PCN-20190827 TE0706-03 Under Voltage Protection Change

Company	Trenz Electronic GmbH
PCN Number	PCN-20190827
Title	TE0706-03 Under Voltage Protection Change
Subject	Trenz Electronic TE0706 Hardware Change
Issue Date	2019-09-05

affected product
TE0706-03

#1 Replaced R34 by 953kOhm and R38 by 147kOhm

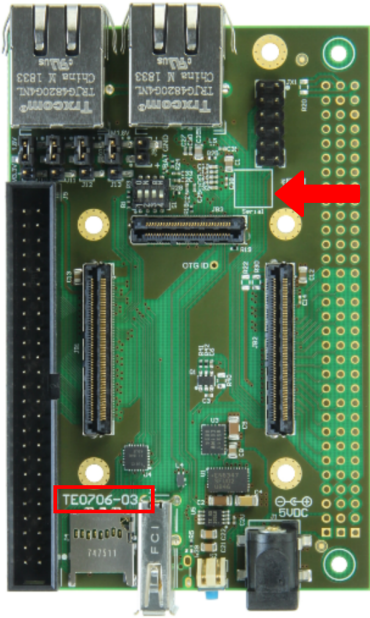
Reason: Large start up currents led due to adverse conditions (e.g. weak powersupply, long wires, increased contact resistance) to a voltage drop below the under voltage lock out limit of the input protection circuit.

Type: BOM change

Impact: Under voltage protection limit is decreased to 4.06V, which gives a larger margin for a voltage drop during start up.
